II. LRR-25

Change Parts : 20 MHz Crystal

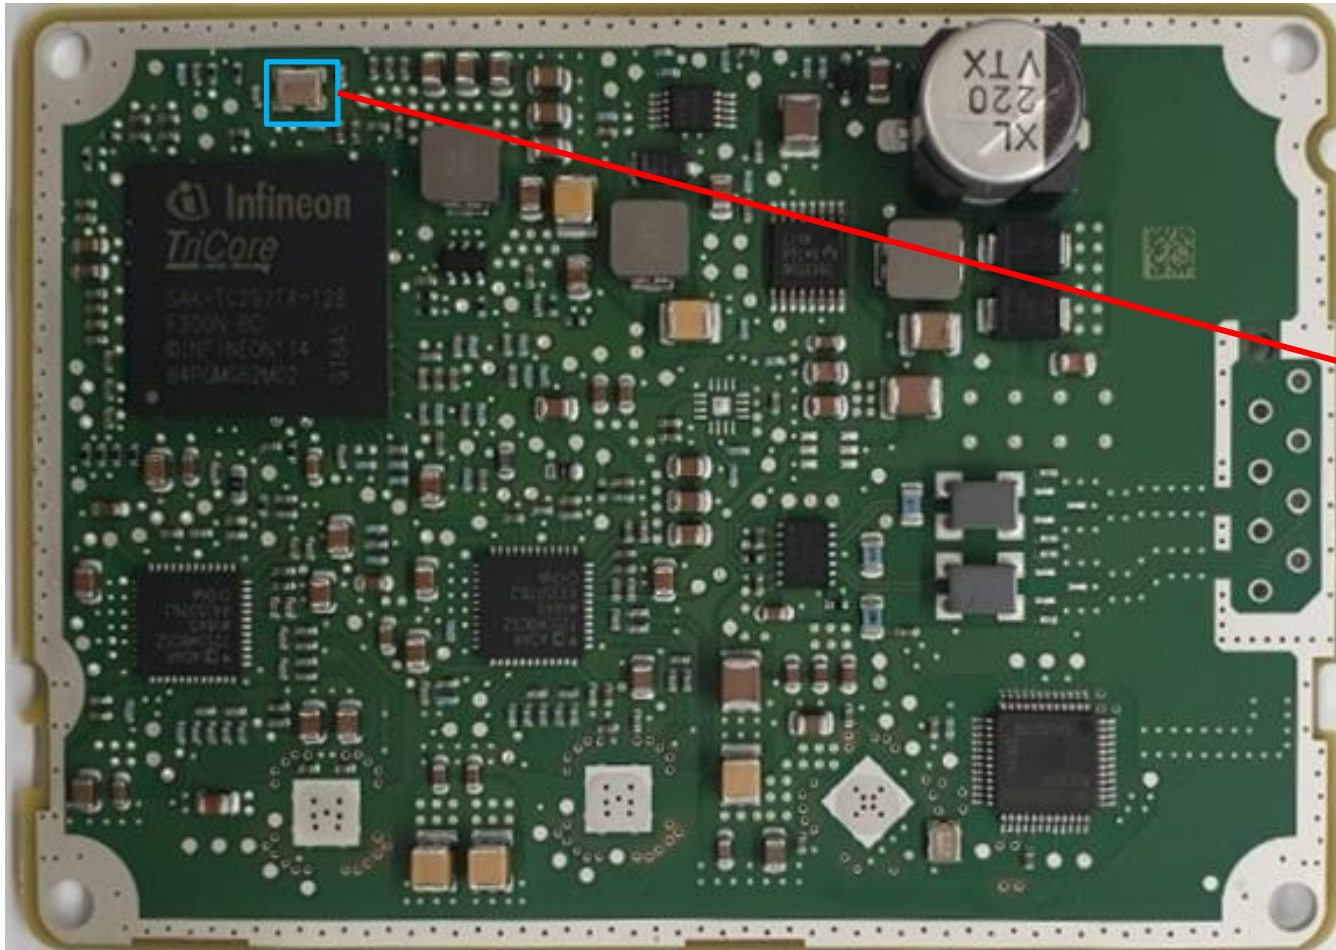
Kyocera CX3225SA20000D0PTWZ1

NDK NX3225GA STD-CRA-1

- 1) Pin to Pin Changed
- 2) No S/W Changed

Change parts : CAN IC

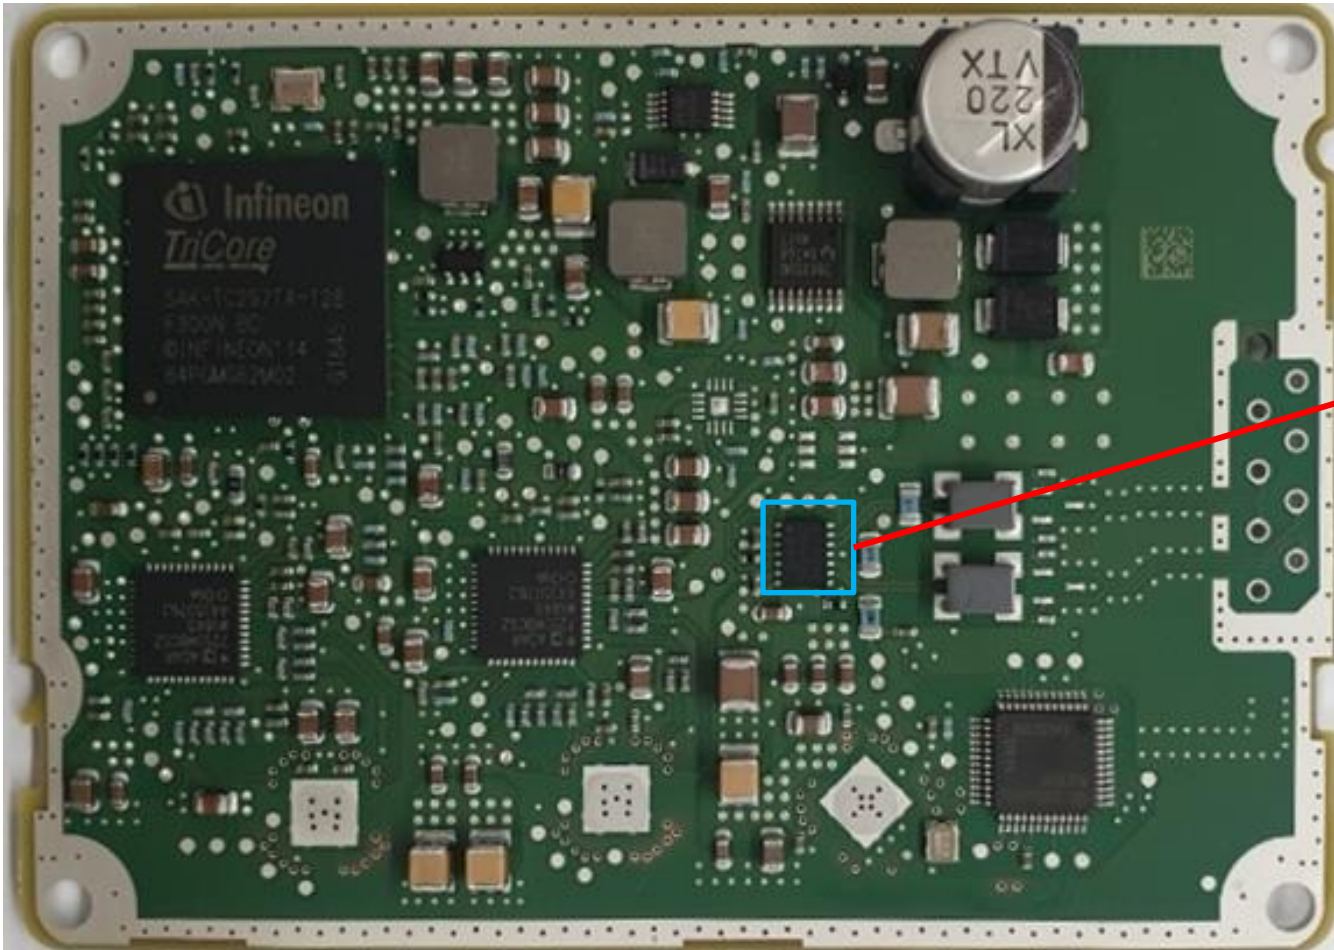
NXP TJA1046TK

TI TCAN1046DMTRQ1

- 1) Pin to Pin Changed
- 2) No S/W Changed
